Access Compliance Report

Public Rights-of-Way (Curb Ramps)

Intersection ID: 10031406	Main Street: MCALPINE_PARK_DR	Cross Street: N/A	Location: SW
ADA ID: 67D37B25B85B	Ramp Type: PerpDiag	Initial Pass/Fail: Fail	Overall Compliance: No Severity Score: 33.75

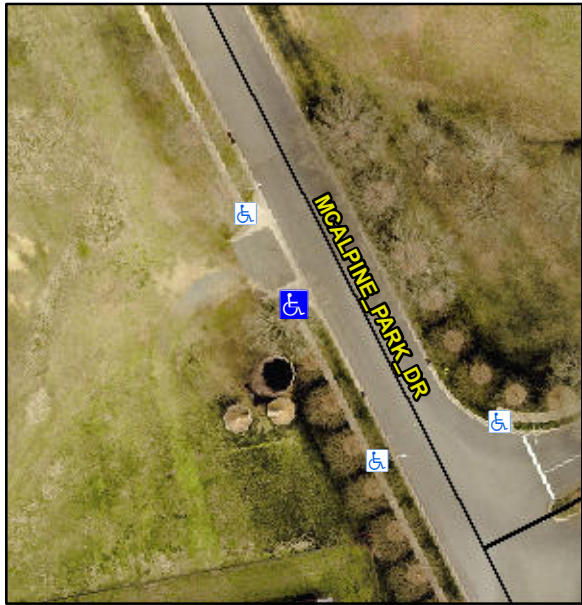
Codes/Mitigation Info/Possible Solution			Field Measurements/Component Compliance							
	Possible Solutions:		Compliance		Description	Data	Compliance		Description	Data
	Remove & Replace Curb Ramp With Two New Directional Ramps or Equivalent.		N/A		Ramp Length (in)	67.0	No		Ramp Slope (%)	9.1
			No		Ramp Width (in)	36.0	No		Ramp XSlope (%)	6.0
			N/A		Flare Type LT	N/A	N/A		Flare Type RT	N/A
			N/A		Flare Slope LT (%)	N/A	N/A		Flare Slope RT (%)	N/A
			N/A		Flare Traversable LT?	N/A	N/A		Flare Traversable RT?	N/A
			N/A		Landing Length (in)	N/A	N/A		DWS Provided?	N/A
			N/A		Landing Width (in)	N/A	N/A		DWS Contrast?	N/A
			N/A		Landing Slope (%)	N/A	N/A		DWS Length (in)	N/A
			N/A		Landing X Slope (%)	N/A	N/A		DWS Full Width?	N/A
Surveyor Notes:	N/A		N/A		Landing Curb? (Y/N)	N/A	N/A		DWS Offset (in)	N/A
			N/A		Shared Landing?	N/A				
			N/A		Gutter Ponding?	N/A	N/A		Gutter Slope (%)	N/A
			N/A		Gutter Lip Ht (in)	N/A	N/A		Gutter X Slope (%)	N/A

N/A		Painted X Walk1?	No	N/A		Painted X Walk2?	No
					X Walk 1 Direction	To NE			X Walk 2 Direction	To NW
			N/A		X Walk 1 Width (in)	N/A	N/A		X Walk 2 Width (in)	N/A
					X Walk 1 Slope (%)	4.1			X Walk 2 Slope (%)	5.0
					X Walk 1 X Slope (%)	1.6			X Walk 2 X Slope (%)	0.5
			N/A		Ramp inside XWalk1?	N/A	N/A		Ramp inside XWalk2?	N/A
				Road Slope (%)	2.8	N/A		Clear Space?	N/A	
				Road X Slope (%)	0.3	N/A		Clear Space to XWalk (in)	N/A	
		N/A		Any Obstructions?	N/A	N/A		Storm Grate/Utility Hazard?	N/A	
				Obstruction Type				Storm Grate/Utility Type		
						N/A			N/A	
							Yes	Surface Condition? (G/P)	Good
